Private Plan Change – Whisper Creek Residential Proposal, Spencerville

Response to stormwater Request for Information (RFI) from Brian Norton.

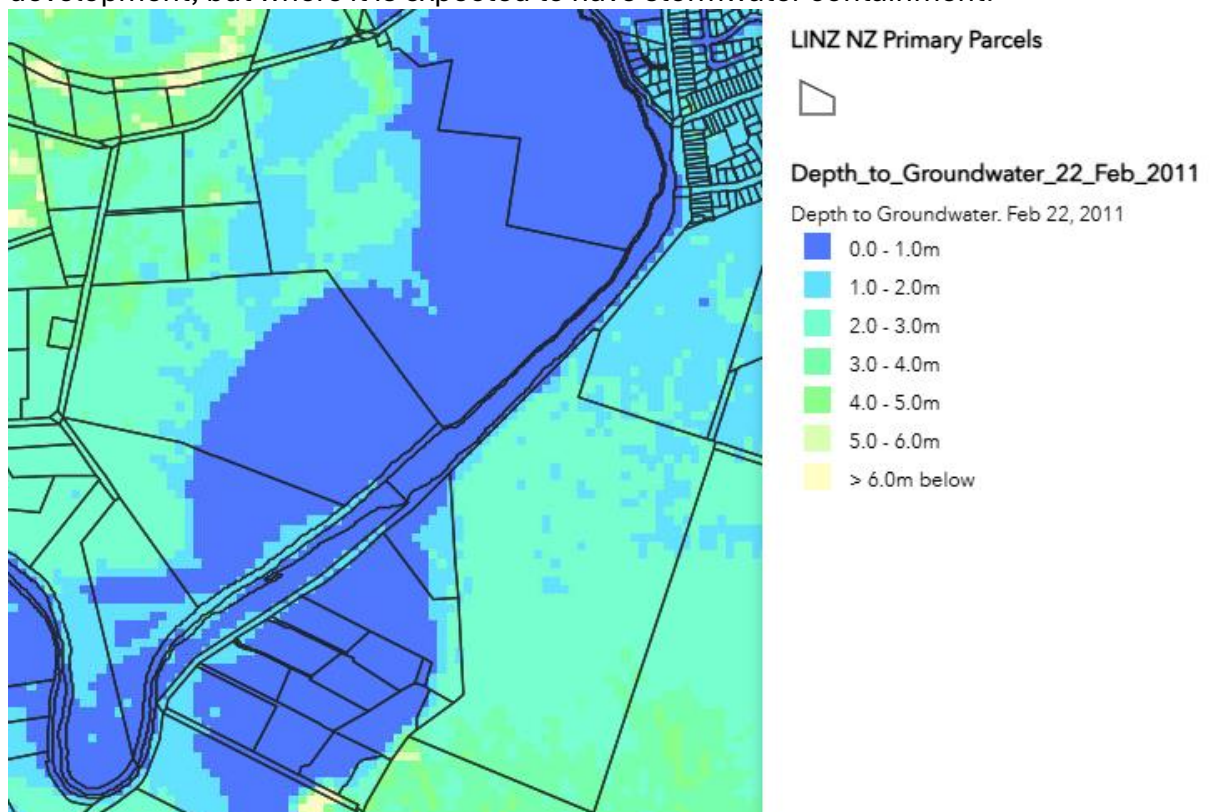
2. The development should be working to protect from a 200-year peak flood water level of 3.08m NZVD (12.49m CDD) and minimum finished floors of new dwellings will be set to 3.48m NZVD (12.89m CDD) which are around 400mm higher than the levels discussed in the infrastructure report.
3. The applicant will need to estimate high groundwater levels considering SLR in high conductivity sands and what measures will be required to mitigate the effects of saltwater intrusion of stormwater facilities proposed.
4. There is an error in their calculations for the stormwater facility sizing. First Flush basin volume is correct, and overall storage volume looks OK, but the wetland area is off by a factor of 2. For some reason they are working to a 0.5m operating water depth of the wetland which simply will not be accepted, because it will be too deep for plants to survive.

$$A = FF/4 * 2 / 0.25 * 0.75$$

$$A = 13,080/4 * 2 / 0.1875$$

$$A = 6,540 / 0.1875 = 34,880m^2 \text{ (NOT } 17,440m^2)$$

4. The error in the sizing of the wetland is accepted. The expectation is that the wetlands will be designed in accordance with the Waterways, Wetlands and Drainage Guidelines.
5. It is accepted that some consideration may be required into the filling of the site and its displacement of storage volumes. At this stage it would be too finer detail to determine this and the further discussion will be required into the application of the correct storm event and the actual effects of filling when the catchment is affected by tides. As mentioned by BN, this can be tested in the flood model once it has been completed.
